Docket Number:	12-AFC-03
Project Title:	Redondo Beach Energy Project
TN #:	201423
Document Title:	Data Response Set 1B â€™ Responses to CEC Staff Data Requests 50, 51, and 53-63
Description:	N/A
Filer:	Sarah Madams
Organization:	CH2M HILL
Submitter Role:	Applicant Consultant
Submission Date:	12/12/2013 2:50:34 PM
Docketed Date:	12/12/2013

Subject: Redondo Beach Energy Project (12-AFC-03)
Data Response Set 1B – Responses to CEC Staff Data Requests 50, 51, and 53-63

Redondo Beach Energy Project

Data Responses, Set 1B (Responses to Data Requests 48-66)

FIGURE DR 54-1
Conceptual Utility Plan for RBEP
 AES Redondo Beach Energy Project
 Redondo Beach, California

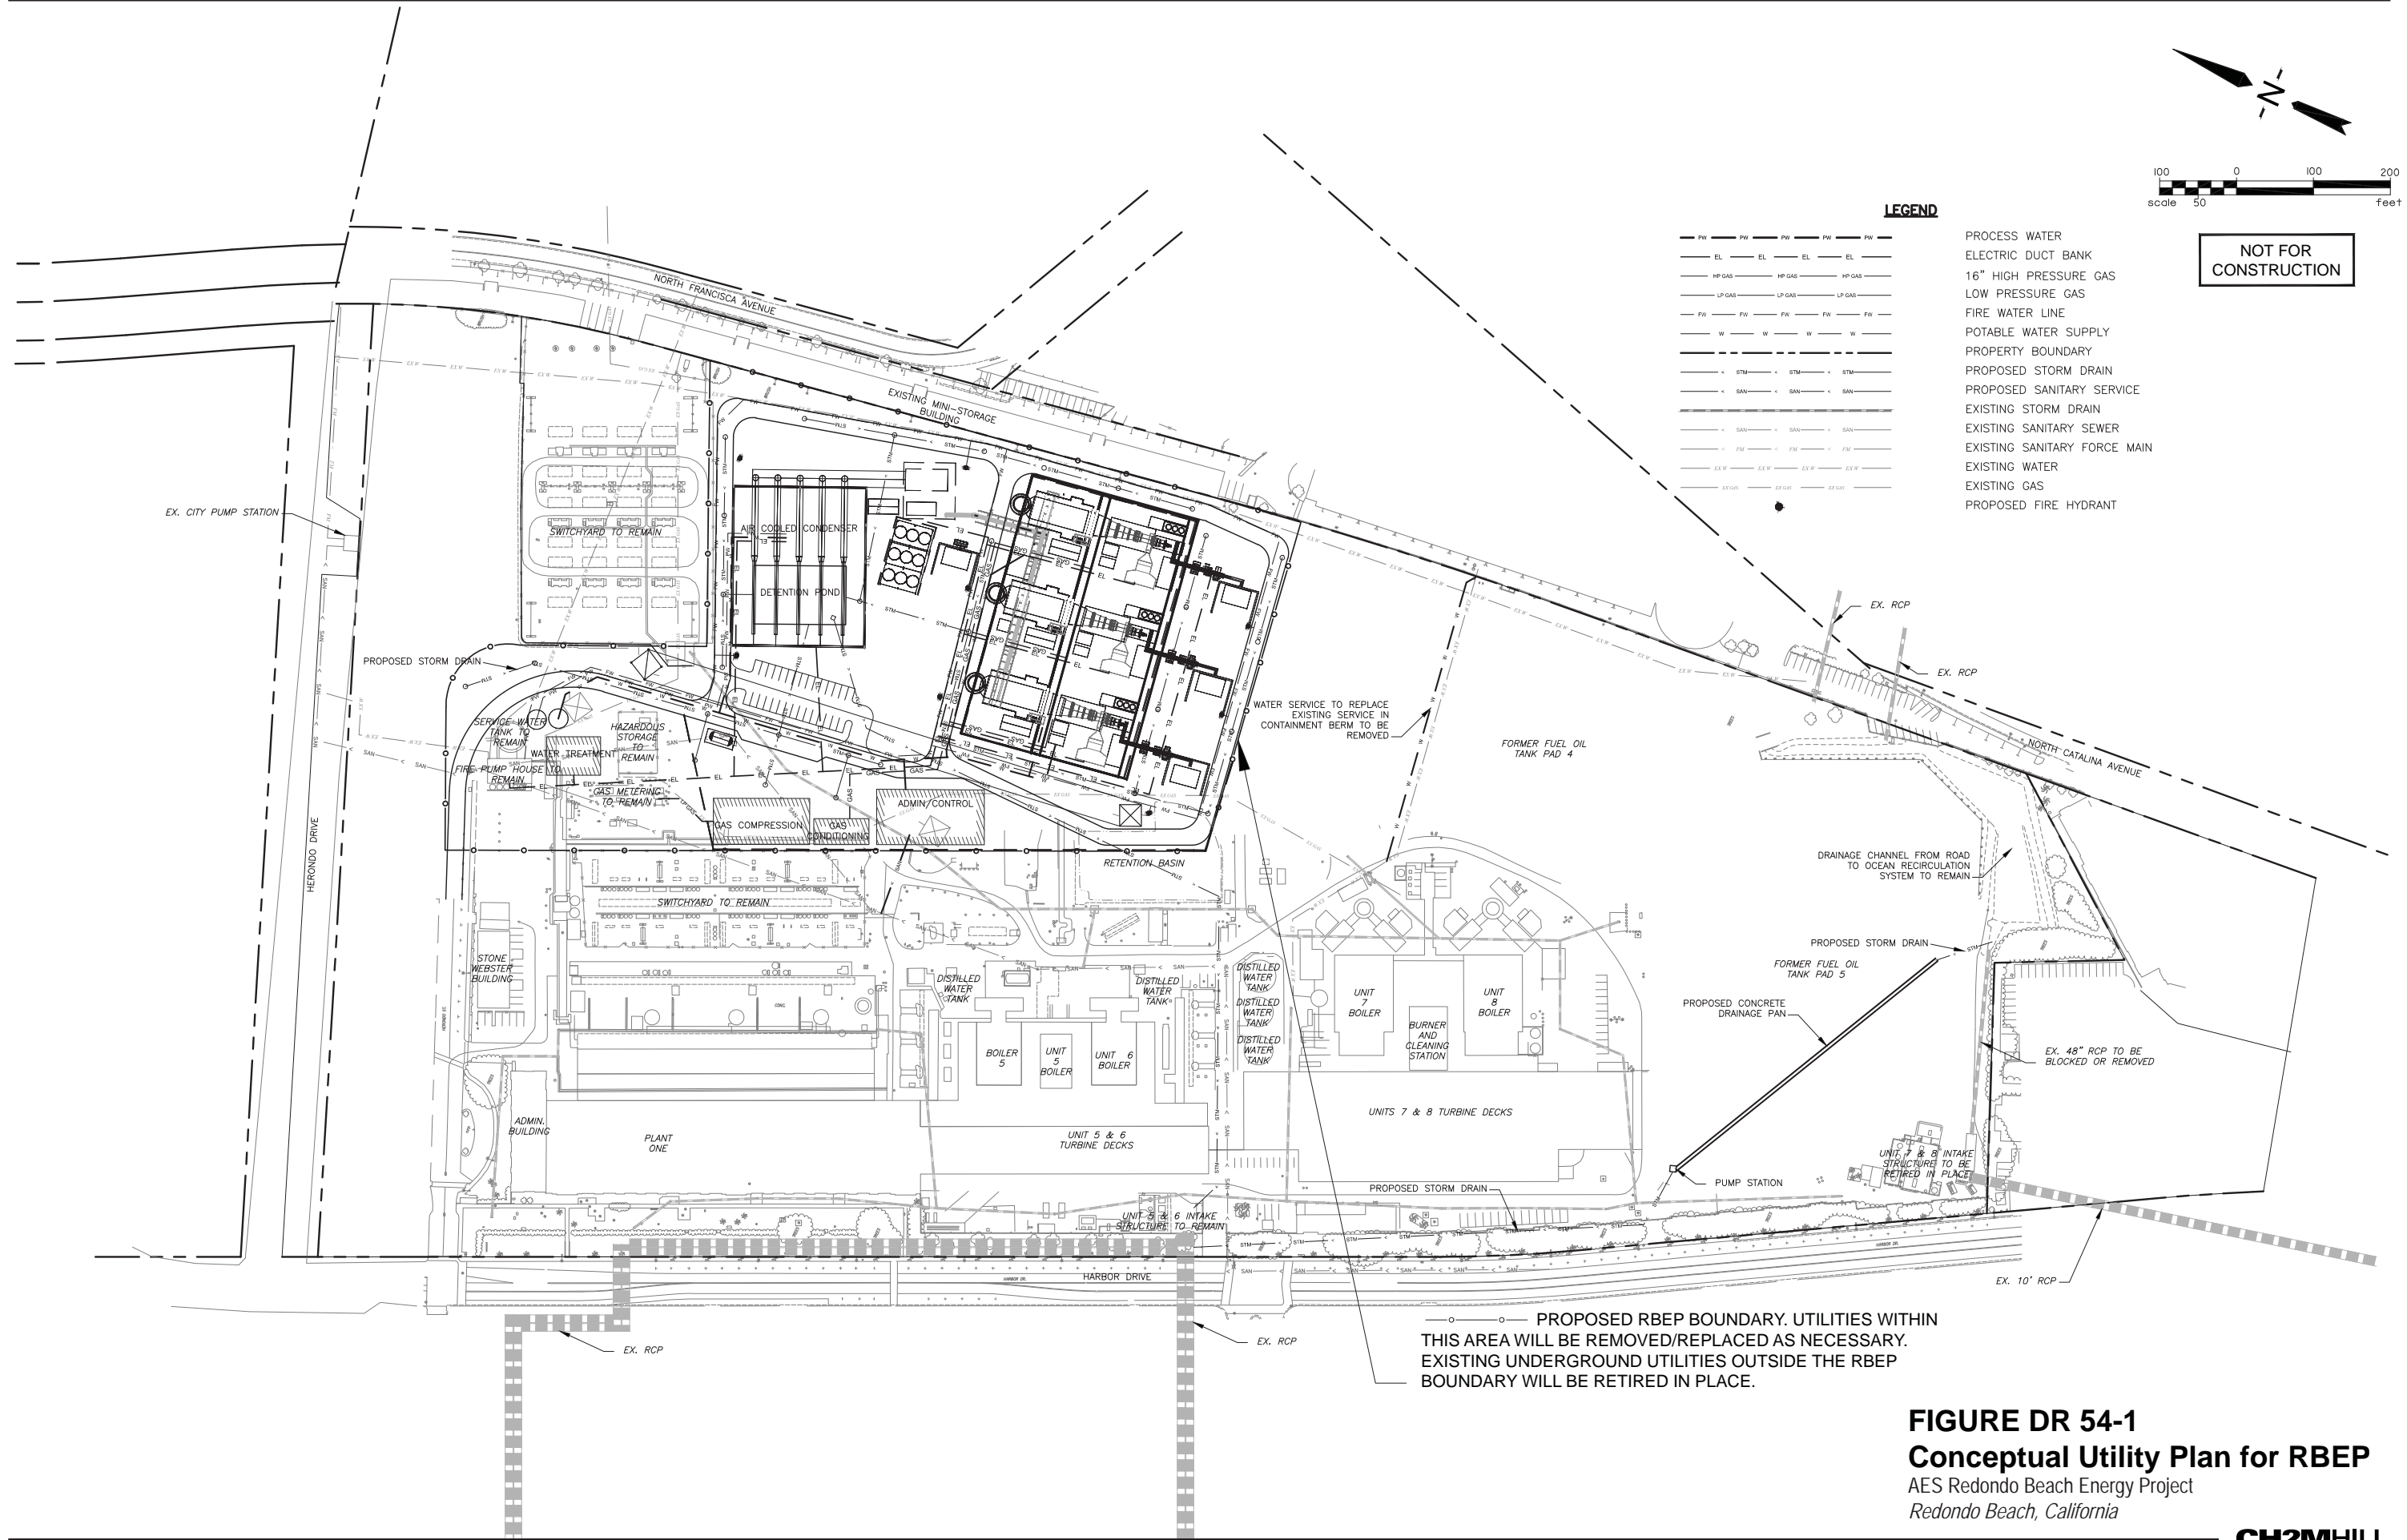
54. Please provide a figure depicting the locations of storm drains that would be slated for removal, at a scale similar to the plans in Appendix 5.15a to the AFC. Also identify the depth of excavation required to remove the storm drains.

Response: The existing and proposed storm drains are depicted in a conceptual utility plan provided as Figure DR 54-1. Figure DR 54-1 also denotes the proposed RBEP. Please note the following:

Existing utilities within the RBEP boundary will be reused or removed as necessary. Existing utilities which are not needed to support RBEP and which are outside of the proposed RBEP site boundary will be retired in place.

- The existing grade level of the area slated for the RBEP, exclusive of the empty tank dikes, ranges from 20 feet above sea level (FASL) to 15 FASL.
- The elevation of the existing storm drain within the RBEP boundary ranges from approximately 17 FASL to approximately 7 FASL.

- The existing storm drain system outside of the RBEP boundary, but within the Redondo Beach Generating Station will remain in place and will not be removed or excavated. Small portions of the existing storm drain system within the RBEP boundary which are located where new equipment foundations will be placed or where excavations are needed for construction will be removed and/or rerouted.

- New storm water drains will be installed within the RBEP to convey rainwater to the new retention pond. The bottom of the proposed retention pond is proposed to be at 10 FASL.

- The top of new proposed storm water drain lines are assumed to have an average depth of 4 feet.
- The top of new potable, process and fire water mains is assumed to be at an average depth of 4.5 feet.

- The top of new natural gas lines are assumed to have a depth of 10 feet.
